# Memorandum

**Re:** Petitions PLNHLC2014-000730 & PLNHLC2014-00628  
New Single-Family Home at approximately 757 N. Wall Street

### New Single Family Dwelling New Construction PLNHLC2014-00730 and PLNHLC2014-00628 757 North Wall Street

**Previous Site Plan**

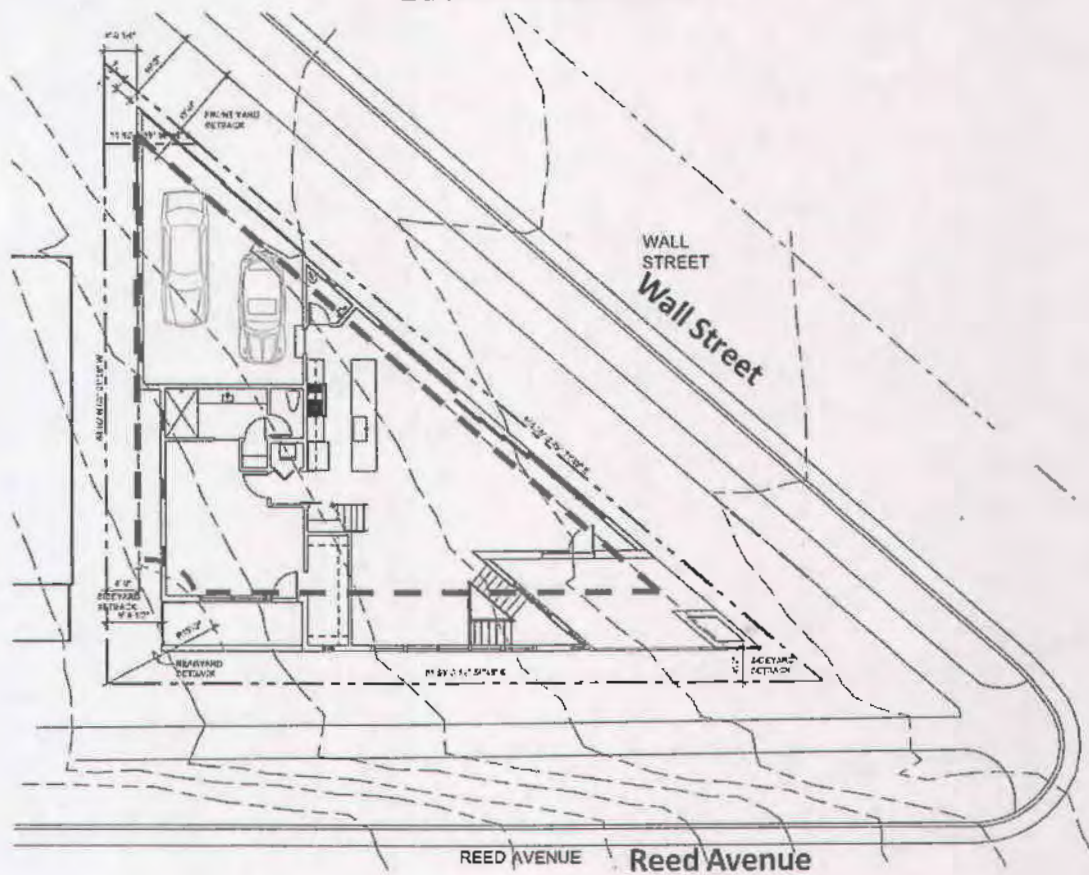
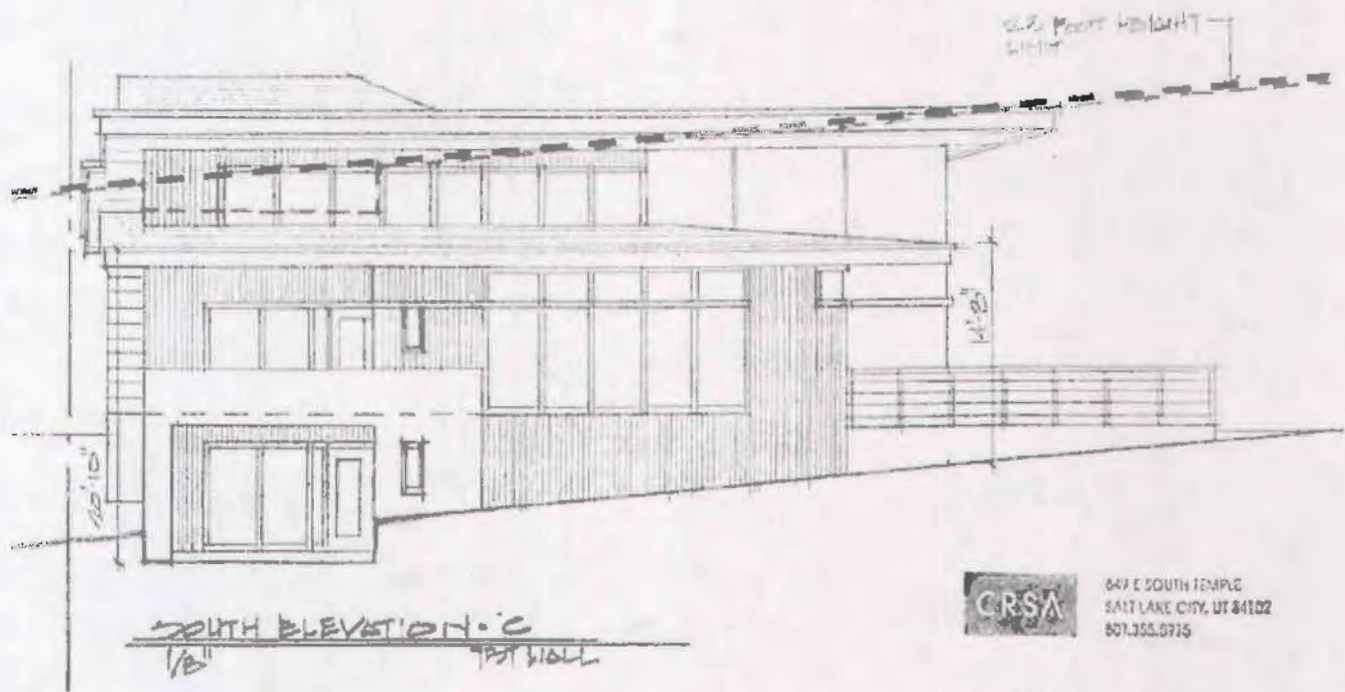
No changes have been made to the setbacks along Wall Street and Reed Avenue. The home is proposed to be 3 feet from the property line and 10 feet from the sidewalk along Wall Street while the setback off of Reed Avenue will also be 3 feet from the property line and 8 feet from the sidewalk.

Based upon the odd shape and small size of the property, the applicant is seeking relief through the special exception process from the 40 percent lot coverage limitations, front yard setbacks along Wall Street and Reed Avenue, and the 23 foot pitched roof height limitation.

**Revised South Elevation and 23 Foot Height Standard**

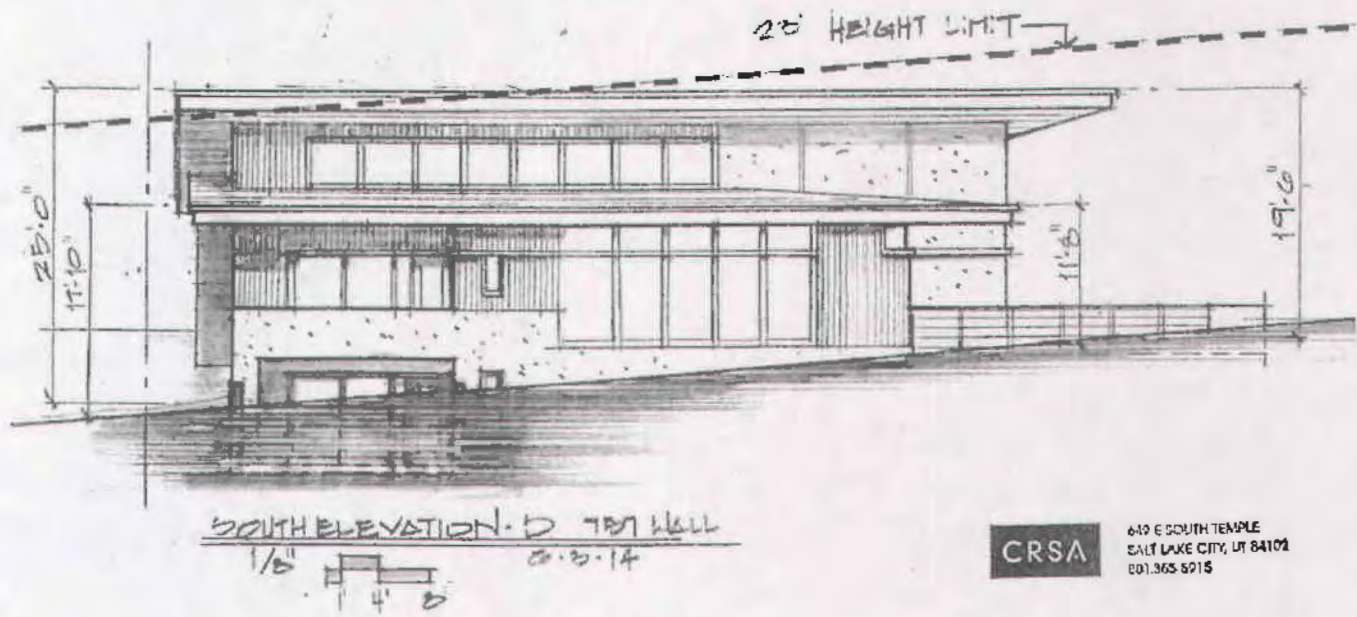
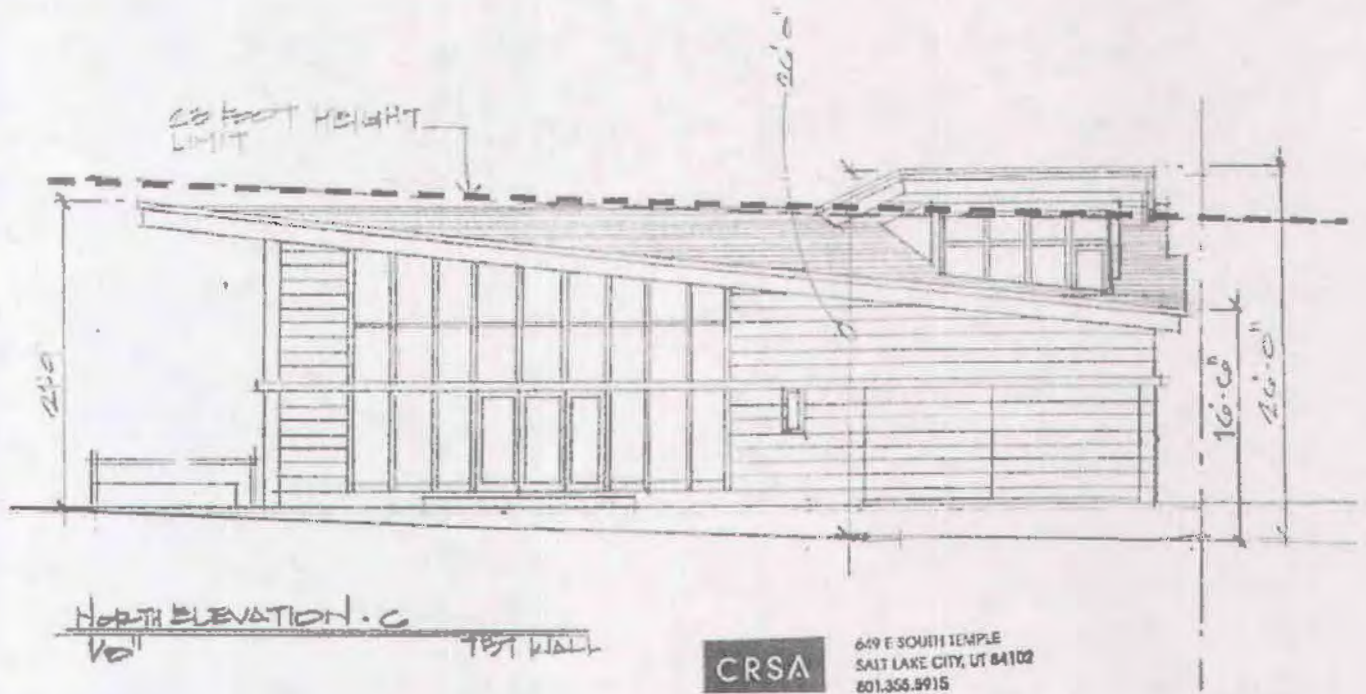
- The home has been shifted one foot to the east in order to meet the interior side yard requirement.
- The roof has been lowered three feet leaving only a small portion of the home that extends above the height limitation of the district. (25 feet at the highest point).

**Revised North Elevation and 23 Foot Height Standard**

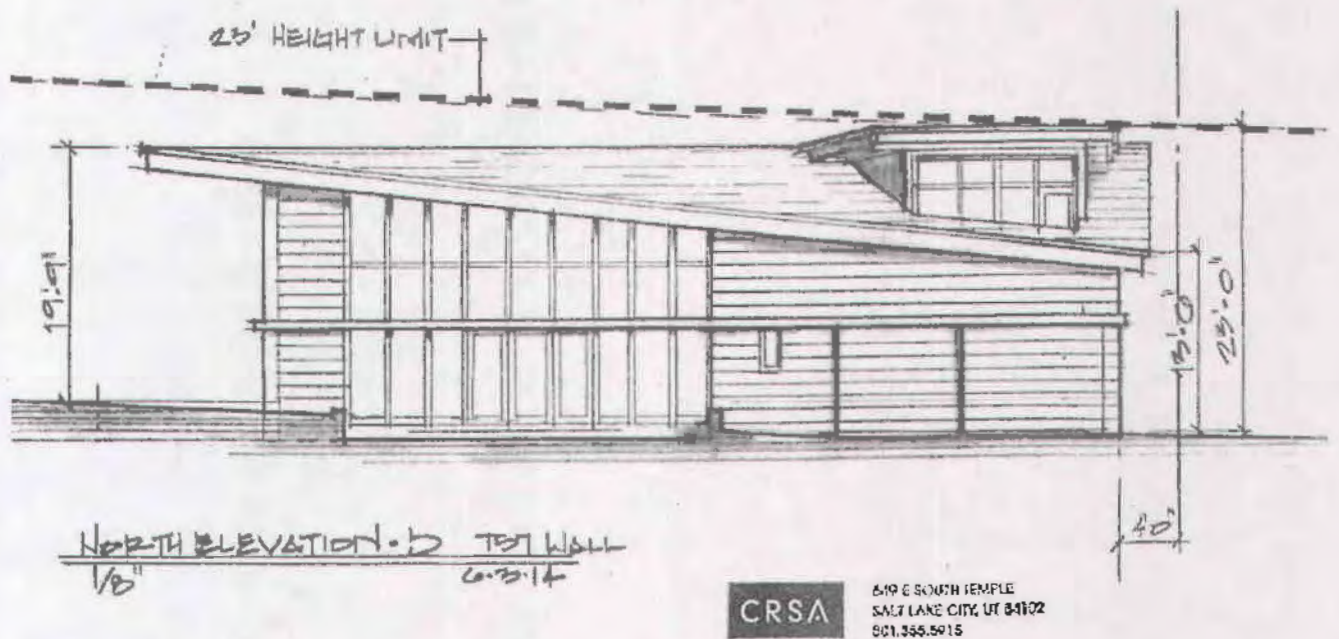
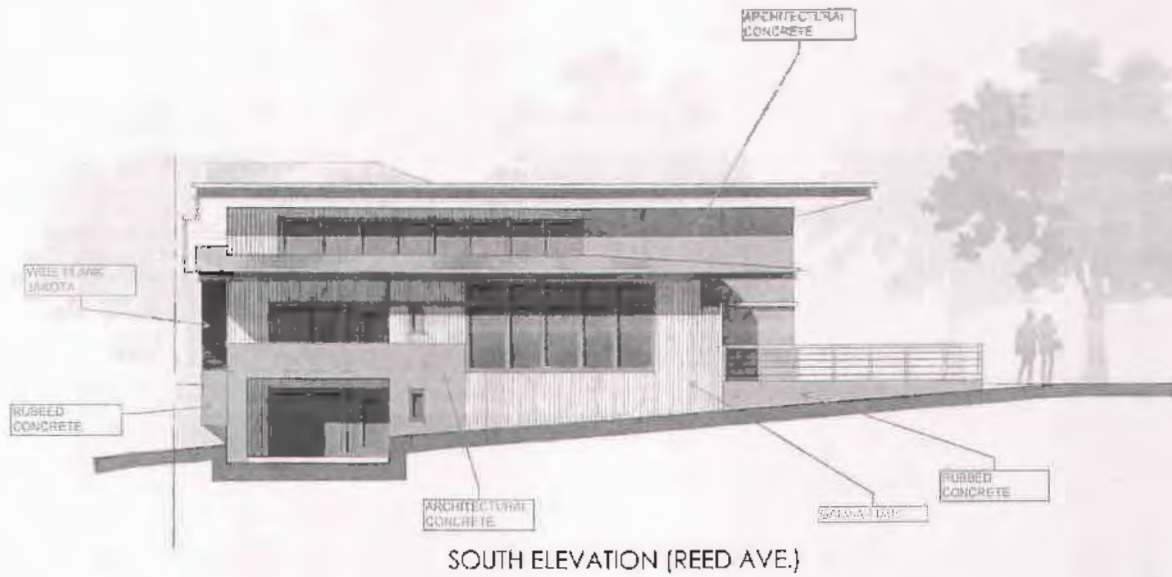
The north elevation will consist of a bank of windows that include sliding glass doors which will serve as the primary entrance. The remainder of the façade will be sided in wide plank wood. As stated earlier, there are only a few homes along Wall Street which were originally brick but have been sheathed in stucco. While large window banks are not normally supported, the street frontage is not clearly defined, allowing for a more innovative approach.

- If the wall of glass was modified it would be approvable, mass along Wall Street was a fairly large flat wall, other than lowering the building, it hadn't changed from the previous proposal.
